Office Action Summary	Application No. 10/589,314	Applicant(s) BOURLION ET AL.	
	Examiner Fangemonique Smith	Art Unit 3736

DETAILED ACTION

FIG. 2A

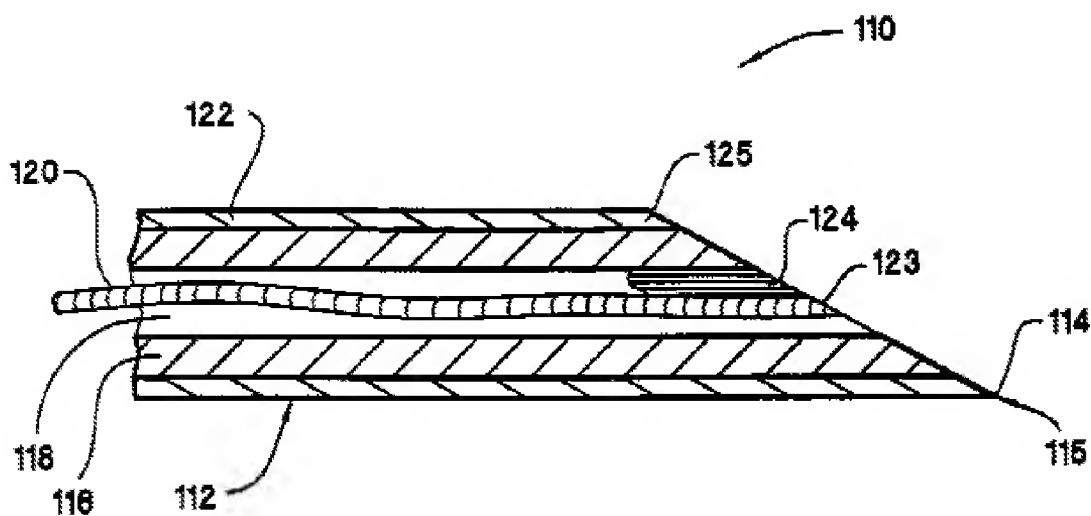
The electrodes are positioned on the penetration instrument for measuring impedance between the electrodes (col. 3, lines 11-53). The electrodes are arranged such that the first electrode has a contact surface coinciding with a distal surface of the penetration instrument and the second electrode has a contact surface coinciding with a lateral surface of the penetration instrument (Figure 2A).

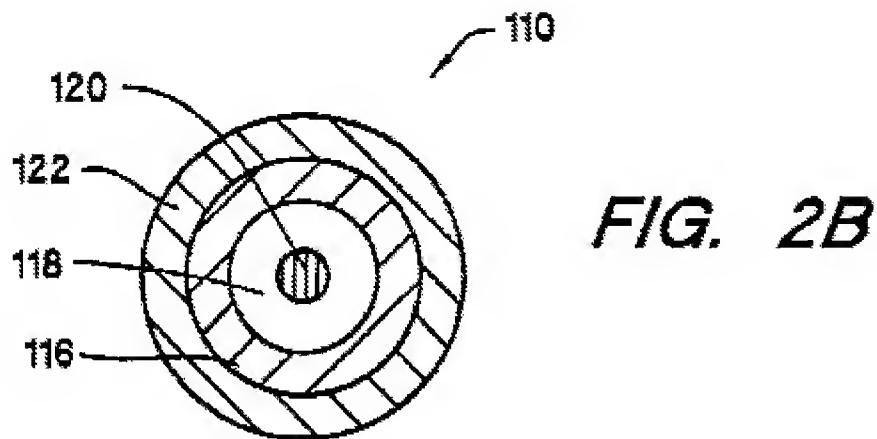
determined. Lum et al. discuss various designs for the penetration instrument including having a constant contact surface which coincides with the degree of penetration of the penetration instrument in the anatomical structure. (col. 3, lines 59-67; col. 4, lines 1- 25). Figure 2B shows the two electrodes being symmetrically and coaxially arranged. This annular arrangement has the electrodes separated from each other by insulation (Figure 2B).

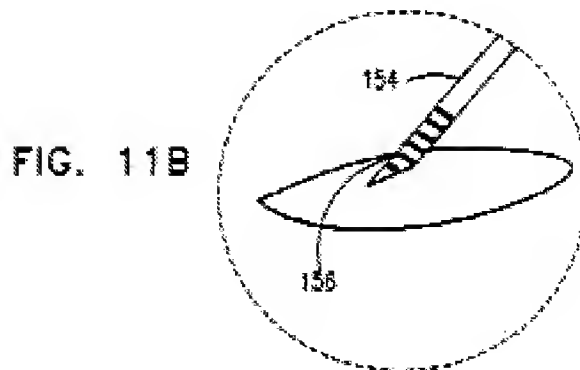
The device is designed to detect signals which are generated to measure the impedance variation and record the information during the analysis. Lum et al. disclose the device having an autonomous operating mechanism in which the device is designed to stop penetration upon reaching a predetermined depth or impedance measurement is reached. A central channel (138) is disposed within the device as described by Lum et al. This lumen is capable of being used to introduce another instrument to the target area.
